Septic Repair

ON-SITE SEWAGE DISPOSAL SYSTEM
HOWARD COUNTY HEALTH DEPARTMENT
BUREAU OF ENVIRONMENTAL HEALTH

ADDRESS: 14055 Howard Road PROPERTY OWNER: Sean and Johanna McGuire

SITE INSPECTION SHEET

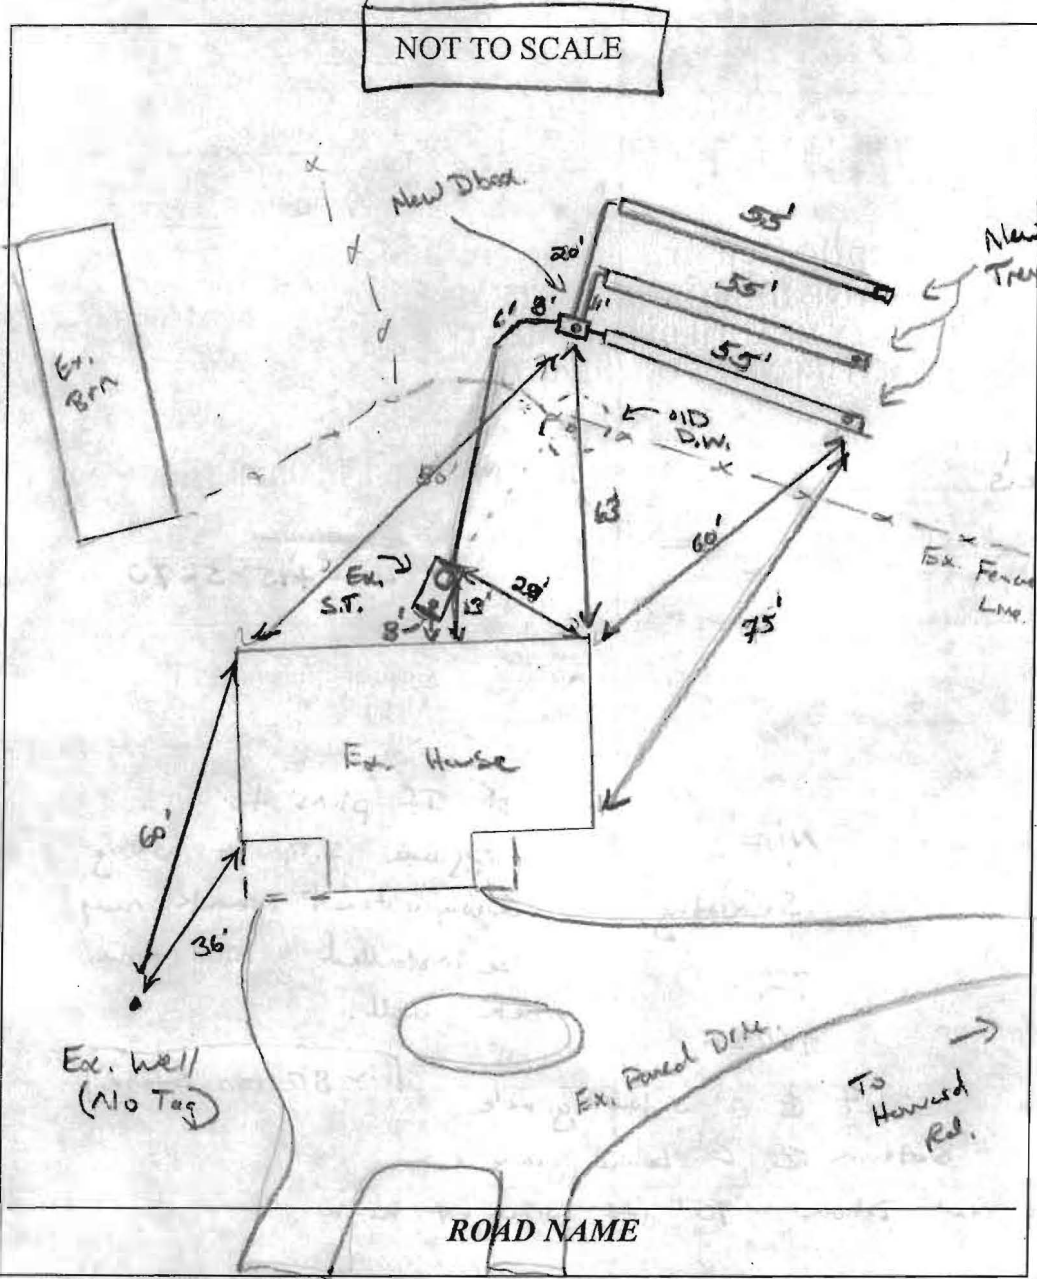
* If plans to upgrade S.T. A 1500g 2 compartment tank may be installed 100' from ex. well.

TRENCHES:	2' wide Inlet @ 2' below grade Bottom @ 6' below grade
LOCATION:	Install new Dbox ~ 75' off corner of house.
PURPOSE:	Pump & collapse existing D.W. Manhole riser needs to be added on existing S.T.

10/3/11 layout given to contractor on site @ time of perc. See permit for installation (KW) 11/9/11 owner called to inform that he might be going w/ another contractor. (KW)

11/1/11 met w/ Fegles on-site. Shot elevations for trenches again. Install 3 x 55' trenches on contour between old D box and

perc. test hole just inside fence. New outlet baffle and manhole ~~needed~~ needed on tank (KW)

12/2/11 New plumbing installed to new D box. Top trench complete. Starting middle trench (KW)

12/5/11 D box leveled. Last trench complete. OK to cover all work (KW)

LOCATION DIAGRAM

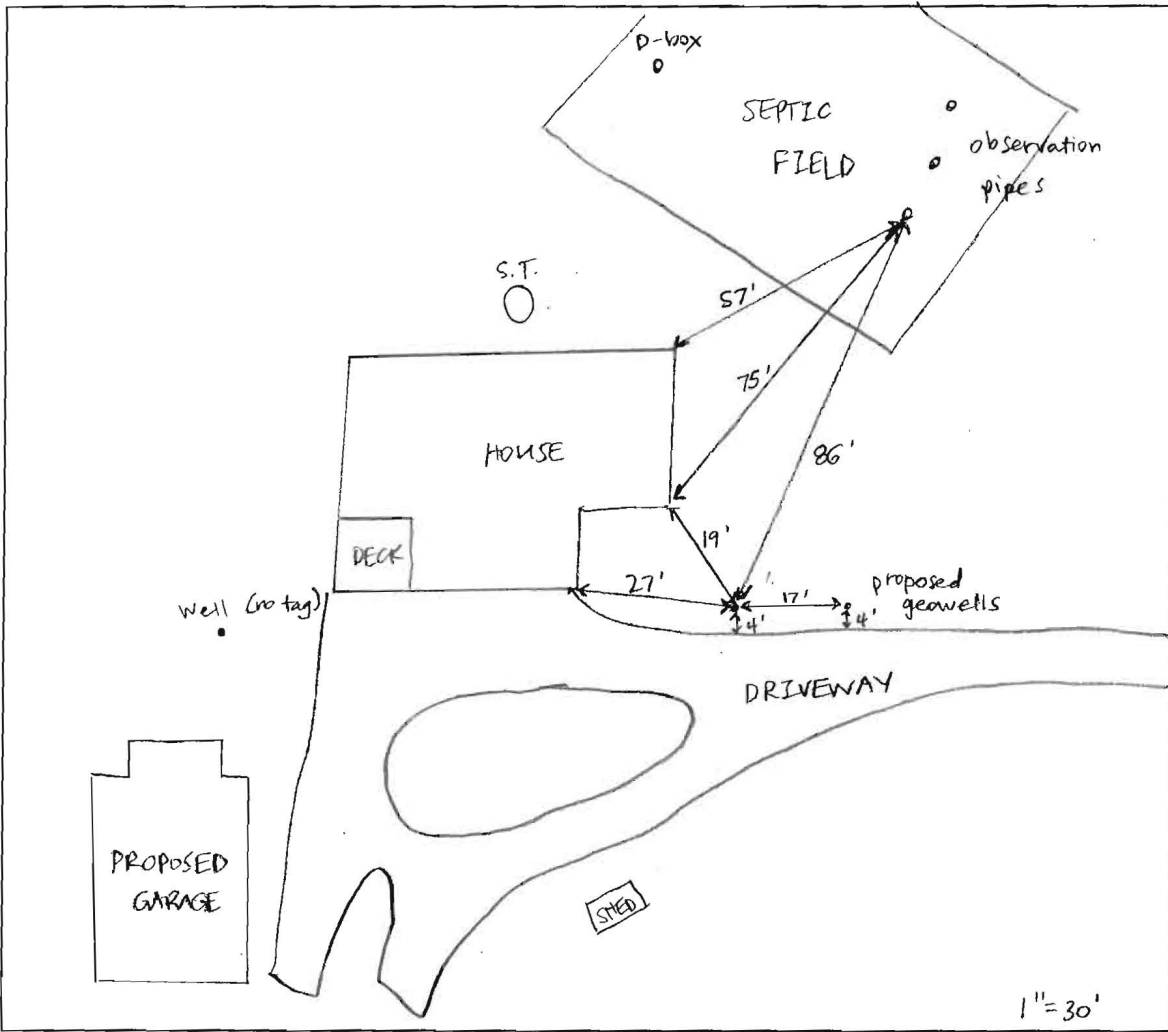
COMMENTS: Site visit to confirm the proposed locations of two geothermal wells.
Well sites staked by Allied. Locations meet 50' setback from septic field
and 20' setback from house. Looked at septic repair from 2011 - observation
pipes all in good condition, no depressions in the yard.
